Application No. 10/510,551  
Reply to Office Action of June 16, 2006  
Response Dated September 18, 2006

**REMARKS**

FIG. 3

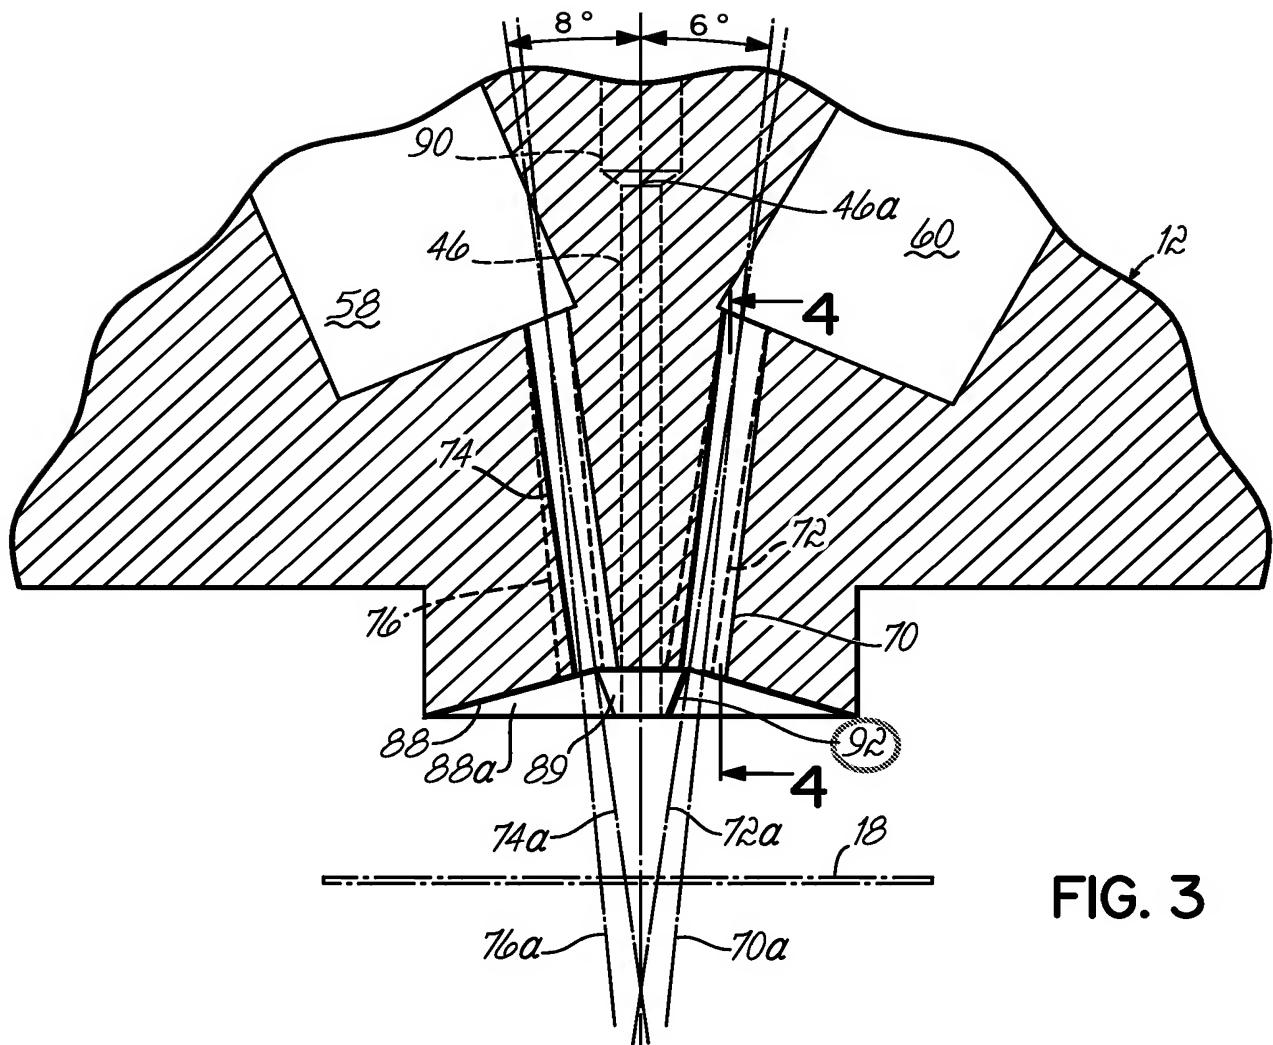
The drawings were objected to for failing to indicate reference numeral 92 recited in the Specification. The drawings have been amended to add reference numeral 92 to FIG. 3. A marked up drawing, showing the changes made to FIG. 3, and a corrected formal drawing are submitted herewith for review and approval by the Examiner. Pending the Examiner's approval, Applicant respectfully requests that the amendment to the drawings be entered and the objections be withdrawn.

The attached drawing sheets include changes to FIG. 3. These sheets of drawings replace the original sheets. In FIG. 3, reference numeral "92" has been added as requested by the Examiner.
